December 17, 1985

ST-HL-AE-1546

South Texas Project  
Units 1 and 2  
Docket Nos. STN 50-498, STN 50-499  
Responses to DSER/FSAR Items Regarding  
Auxiliary Feedwater System

Attachments: Responses to DSER/FSAR Items Regarding  
Auxiliary Feedwater System

Figure II.E.1.1-1 Feedline Break

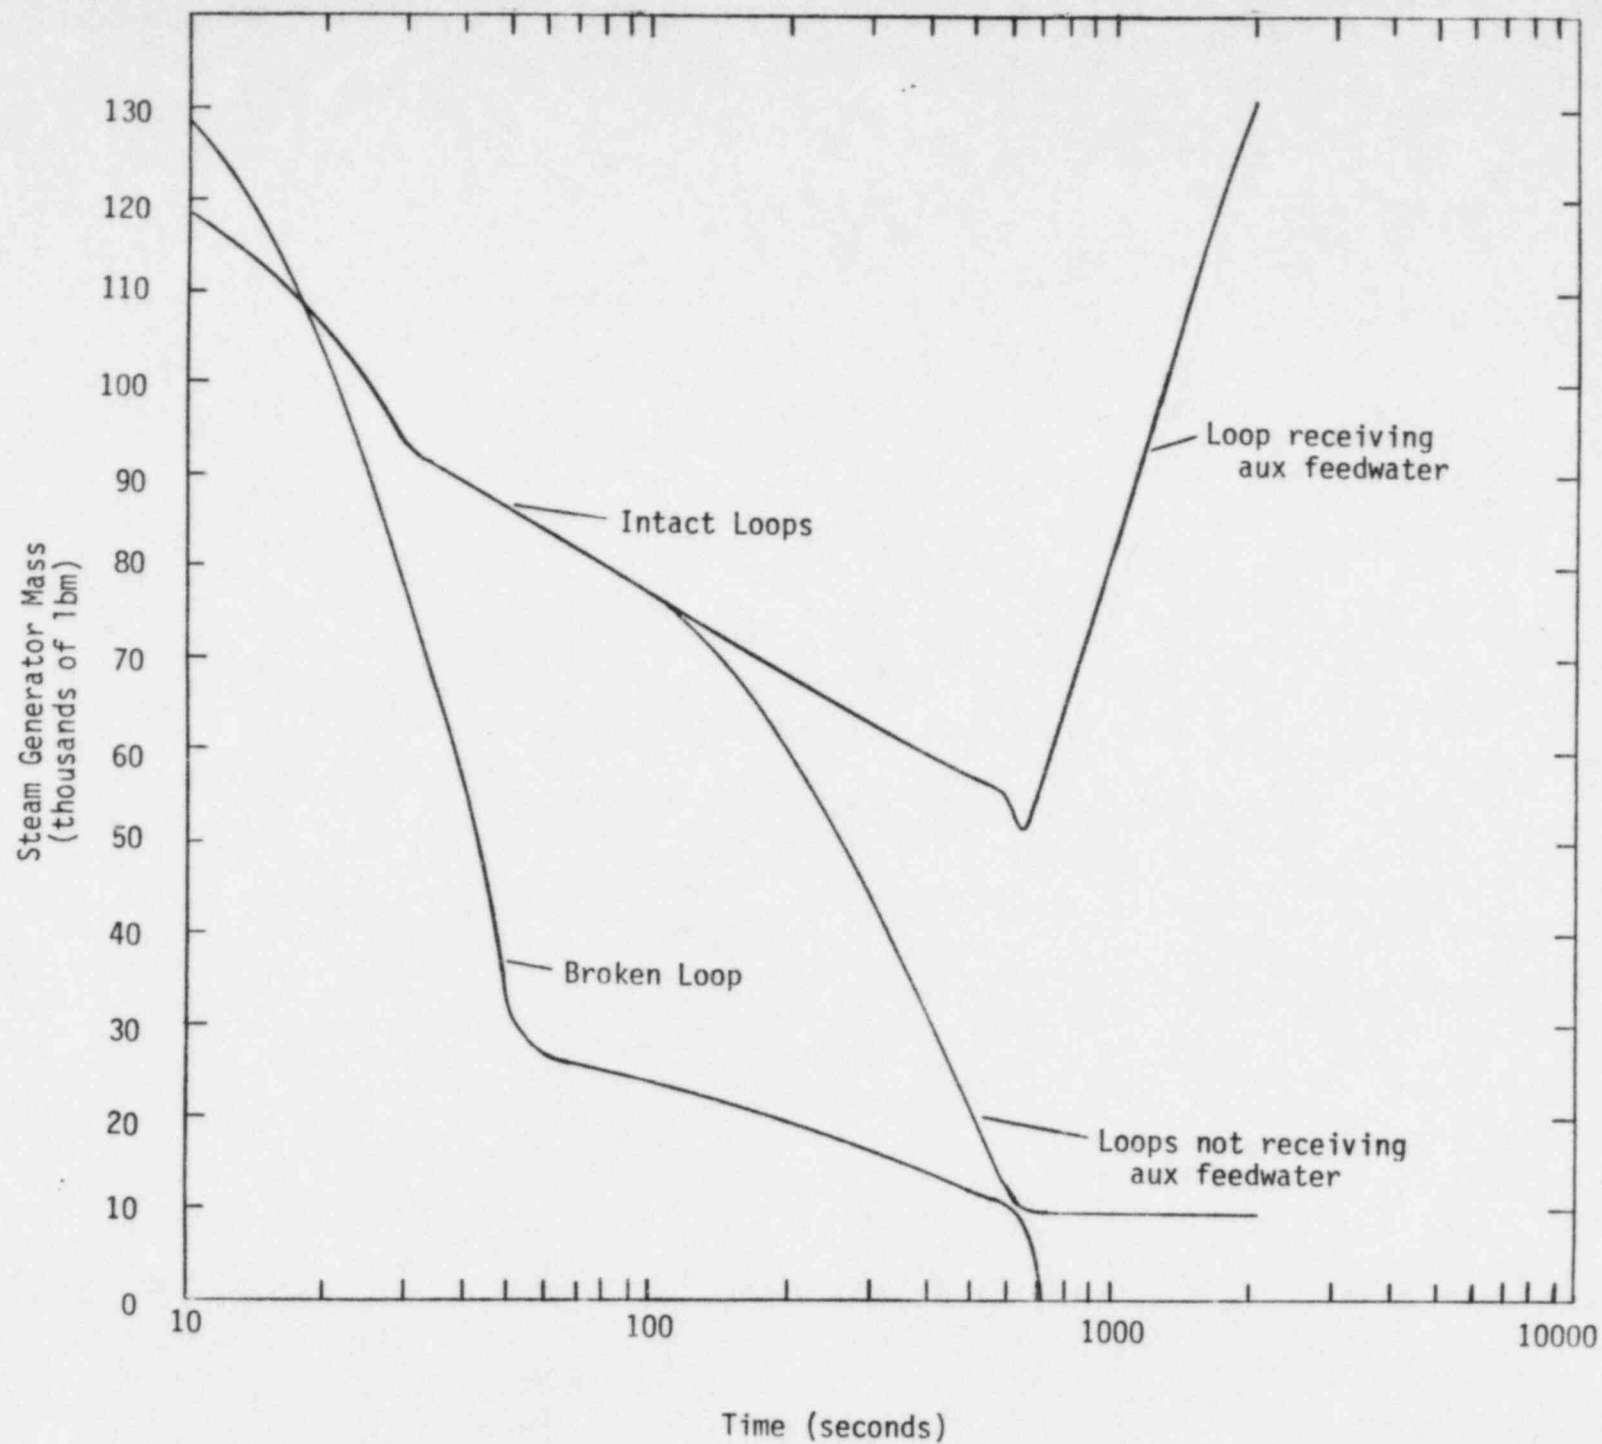
d. SG water level at time of reactor trip	(low-low SG level) 27.9% NR span 91,344 lbm	N/A	(low-low SG level) 27.9% NR span 86,625 lbm	N/A
e. Initial SG inventory	118,829 lbm/SG	98,100 lbm/SG at 556.3°F	Broken Loop - 128,874 lbm consistent with power Intact Loop - 118,829 lbm	
Rate of change before & after AFWS actuation	See FSAR Figure 15.2-10	N/A	See Figure II.E.1.1-1	N/A
Decay heat	ANS-5.1-1979 + 2 $\sigma$	N/A	ANS-5.1-1979 + 2 $\sigma$	ANS + 20%
